Special Meeting Agenda City of Sacramento Design Commission

3. **P10-042 Oak Park Mixed Use Development** (Noticed on 9/01/10)
Location: 3820 Broadway, District 5, 014-0171-001-0000, 014-0171-017-0000, 014-0171-018-0000, 014-0171-019-0000, 014-0171-020-0000, 014-0171-025-0000
Recommendation: Approve- Item A: Environmental Exemption (Per CEQA 15332); **Item B:** Mixed use development including a 56 unit Senior Housing component and 4,000 square feet of retail, and 42 parking spaces, on a C-1 parcel merger in the Broadway/Stockton Special Planning District and Oak Park Design Review District.
Contact: Matthew Sites, Associate AIA, LEED AP, Design Review Staff, 916-808-7646; Luis Sanchez, AIA, LEED AP, Senior Architect
- Action: Moved, seconded, and carried (Sehnert/Fong; 4:0:3, Absent- Miyamoto, Chandler, and Nybo) to continue the item to a Special Meeting on October 13, 2010.**

Subject: **3820 Broadway (P10-042)** Located at the southeast corner of Broadway and Martin Luther King Jr, Boulevard, a request to develop a three story 56 unit residential with ground floor retail on 1.2+/- acres in the Broadway/Stockton and Oak Park Special Planning District (C-1-SPD) zone.

After the he

BOLLARDS

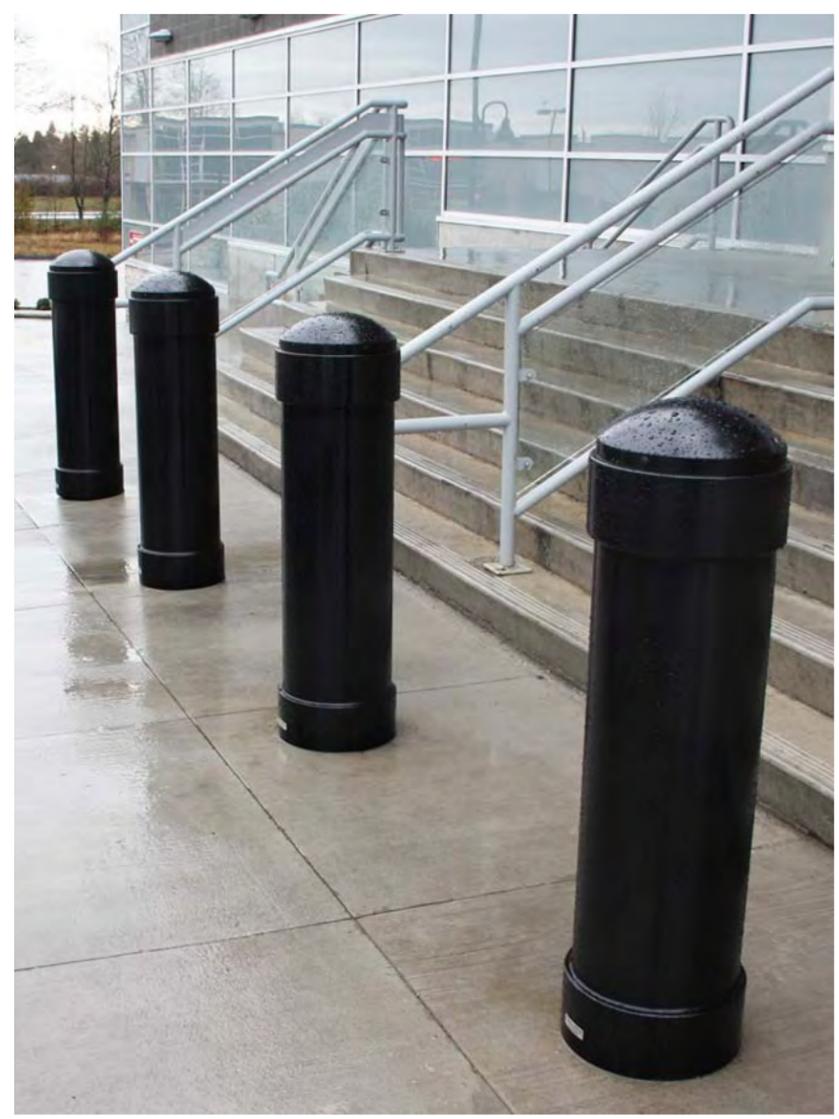
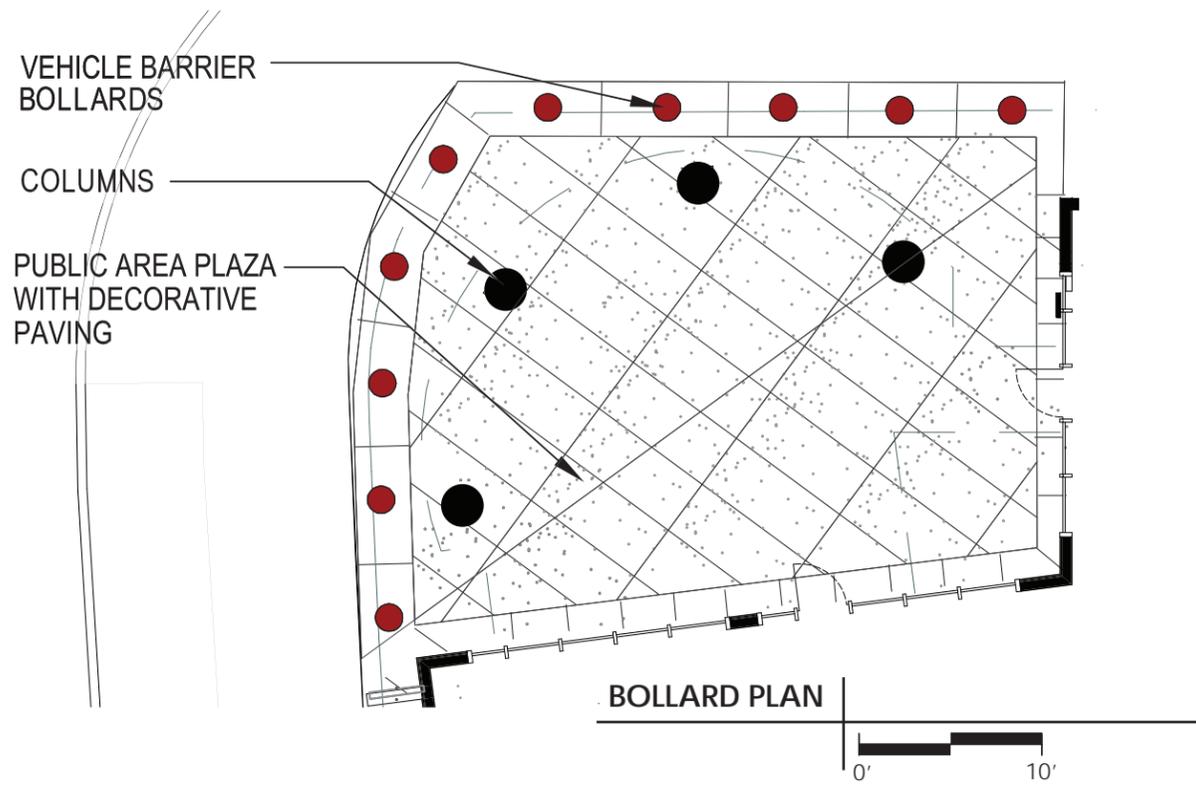
3. The bollard configuration and design at the corner of Broadway and Martin Luther King Jr. Boulevard has been adjusted to utilize concrete and/or steel bollards in place of Corten steel planters. **The applicant has provided an enlarged plan and photos of potential bollard styles.** Staff supports the use of bollards instead of planters, but recommends articulation of the bollards that will better complement the design **of the columns**. Staff feels that the layering of bollards and columns makes the space uninviting, so attention to the articulation and layout of the bollards and columns is paramount. Staff recommends smaller bollards **(maximum of 12" diameter and 42" in height)** clad to complement building materials **(clear anodized finished aluminum, which staff feels will not draw additional attention to the bollards)**, and round column bases. **In addition to the smaller bollard size, staff suggests the outer two bollards to the east and to the south be removed to provide additional pedestrian access and activation at the street.** ~~Details and cut sheets of the bollards should be provided to the Design Commission at the hearing.~~

BRICK TRELLIS COLUMN | NOT TO SCALE

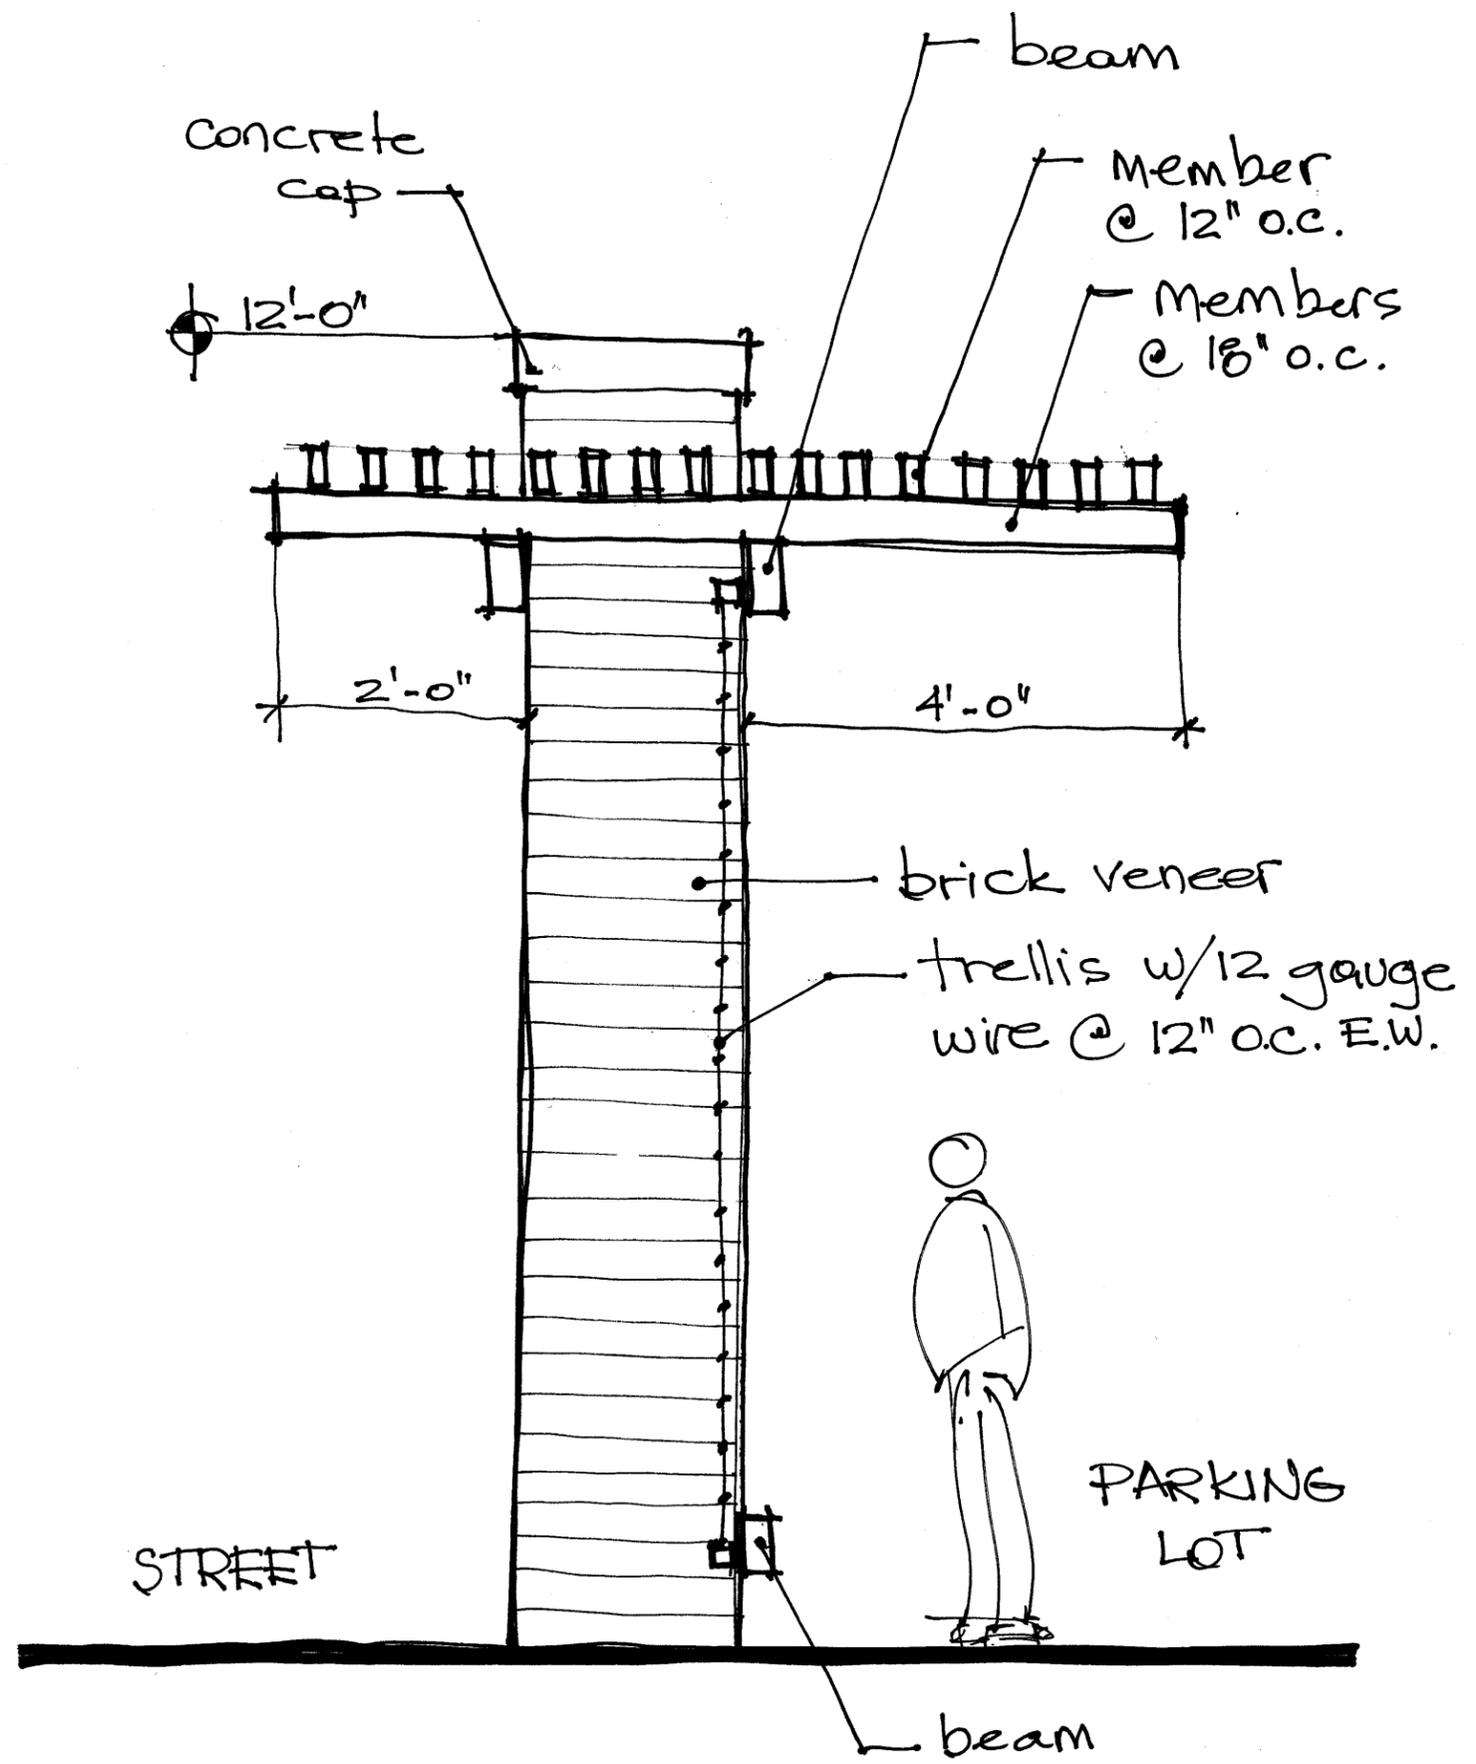
6. The trellis element has been placed closer to the street to allow additional room for site mechanical systems. Staff recommends relocating the double check valve behind the trellis element **where possible**, but should retain the Fire Department connection and post indicator valve at their present locations. The trellis element consists of brick columns with metal trellis and mesh for vines. **A trellis detail was provided for staff review, and staff supports the design with a few minor revisions. Staff recommends a different coursing at the top of the brick column instead of the proposed concrete cap, as it is introducing another material in a relatively small element that has plenty of material changes already. Detail drawings of trellis have not been provided for staff review, and should be provided for review and action by the Design Commission at the hearing.**

9. Brick ***columns with brick cap*** and prefinished metal trellis shall be provided ***per detail provided at the hearing. per approved plans. Where insufficient information is provided at hearing to allow Design Commission approval, Design Commission may relegate to staff that*** **The final trellis element details shall be provided for review and approval by Design Review staff prior to Building Permit submittal.**

PERIMETER CMU WALL 19

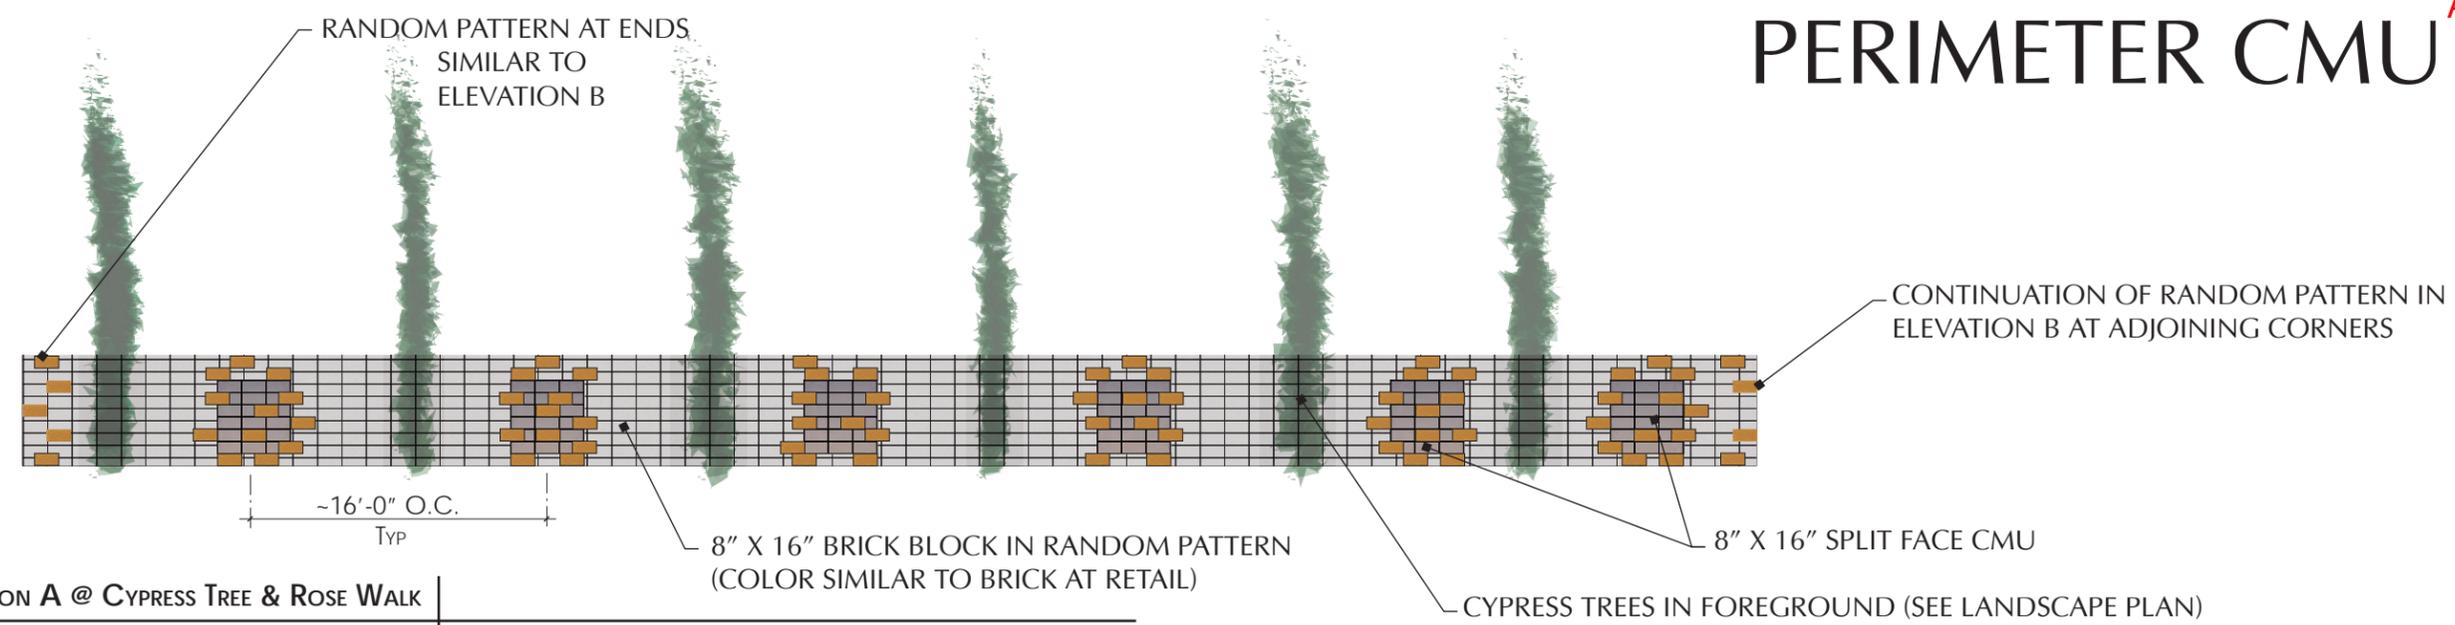
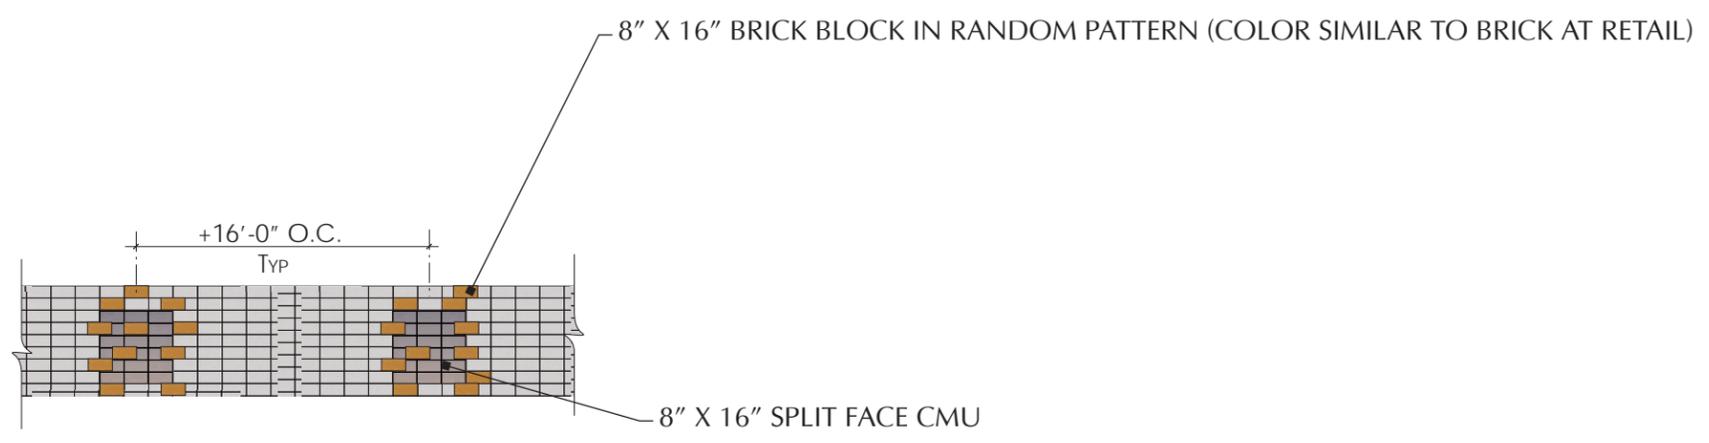
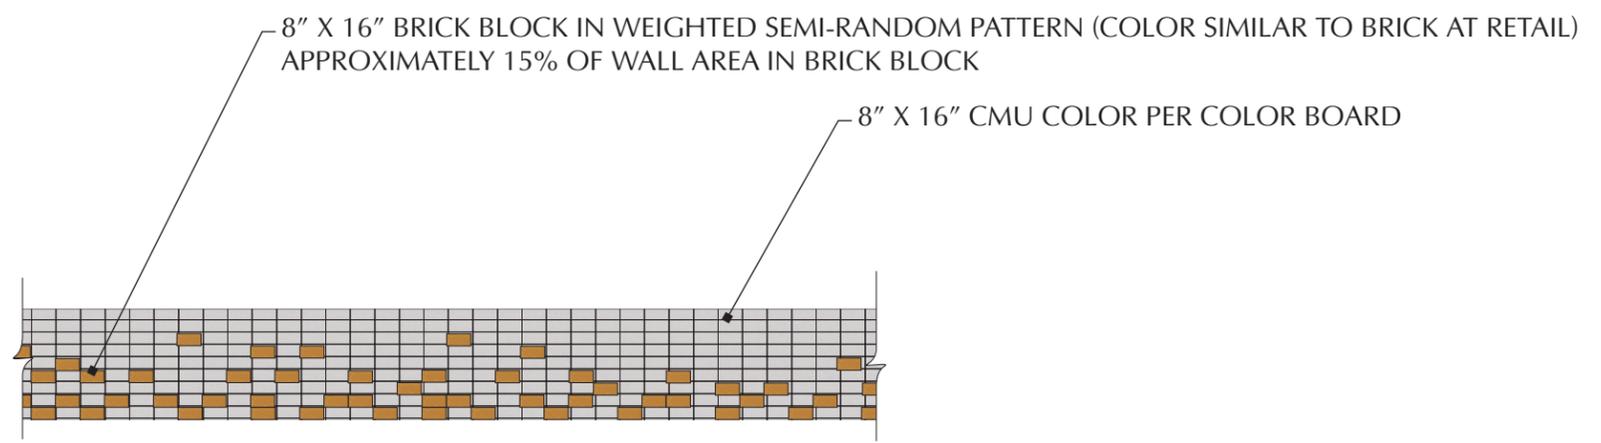
7. The applicant is proposing relief in the CMU separation wall at the south edge of the property adjacent to the residential zone, **and has provided an exhibit for review. but has not provided exhibits reflecting this modification. Staff supports relief in the CMU wall, but requires exhibits be provided at the Design Commission hearing for review and action by the Commission. Staff recommends that the Elevation B design be provided at all elevations of the CMU separation walls.**
